Special inspection to increase the TBO for engine type 912 UL

Increase of TBO from 600^h/10 years to 1200^h/15 years.

Generally all engines of Series Type 912 UL up to and including engine No. 4,152.666 From engine N. 4,152.667 onwards the 1200^h TBO is covered by SI 26 UL-94.

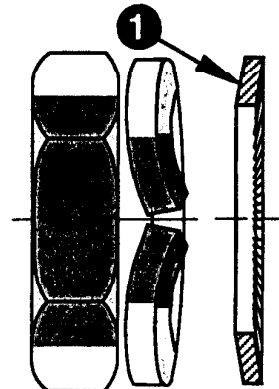
If hex. nut is still secured by a lock washer, it has to be exchanged for the friction washer ①. Slide drive gear of the exchange gearbox on cleaned serration of crankshaft and fit friction washer and hex. nut M30x1,5.

■ ATTENTION: Secure hex. nut with LOCTITE 221. Hex. nut with L.H. thread.

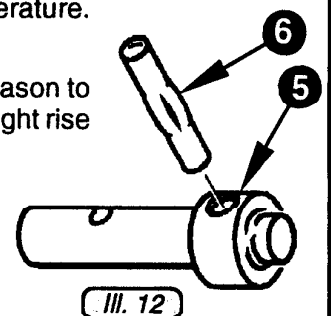
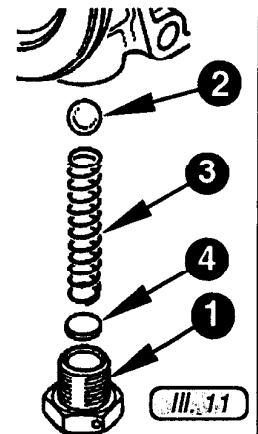
Remove plug screw ❶ of pressure relief valve ❷, clean valve and check ball seat in housing. Clear all oil passages by compressed air. From engine serial no. 4,005.186 onwards, to improve oil pressure control the following parameters of the relief valve were changed. Free length of the compression spring ❸ was reduced from 46 mm to 39,5 mm. Spring rate was changed by increase of wire dia. from 0,8 mm to 0,9 mm, and dia. of ball was increased from 8 mm to 8,5 mm.

◆ **NOTE:** Starting with engine N. 3,792.944 the oil pump housing and oil pump cover is in pressure die cast. On this occasion capacity of the pump was increased by lengthening of the rotary piston assembly from 13 mm to 16 mm along with the respective changes of oil pump housing, pump shaft and O-rings.

From engine serial no. 4,152.101 onward the follower in the oil pump shaft ❺ was changed to notched pin ❻ instead of the former dowel tube.

At a renewal of components change oil pump to the version with the 16 mm long rotors.

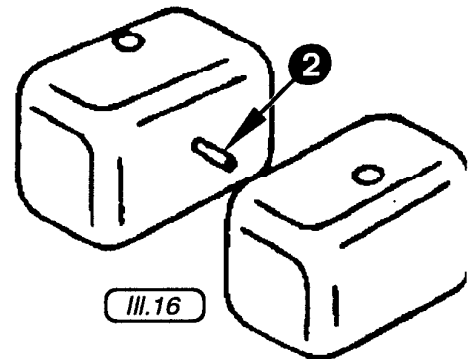
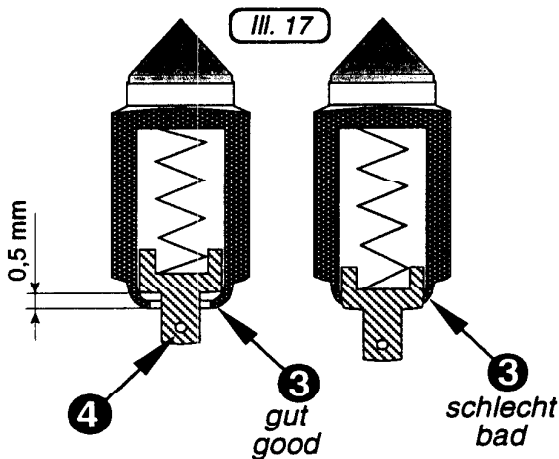
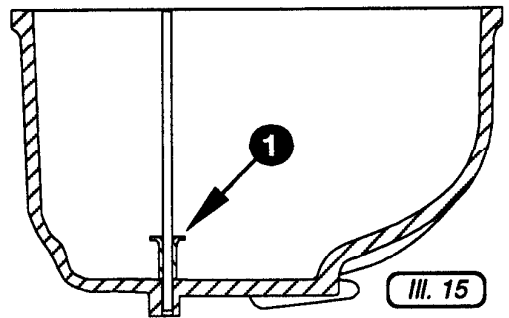
Remove float chamber and lift out both floats. If float chamber is still without distance pieces ① part no. 861 920, add them now, thus avoiding possible sticking of the floats in the float chamber.

Check support pin ② of floats. At heavy wear of float bracket contact faces, caused by excessive vibration, renew float and float bracket as required.

Examine float valve with float chamber removed. At noticeable wear of beaded edge ③ at the sprung pin ④ the valve has to be renewed. If the distance becomes less than 0,5 mm (see ill. 17) the float level will be effected too.
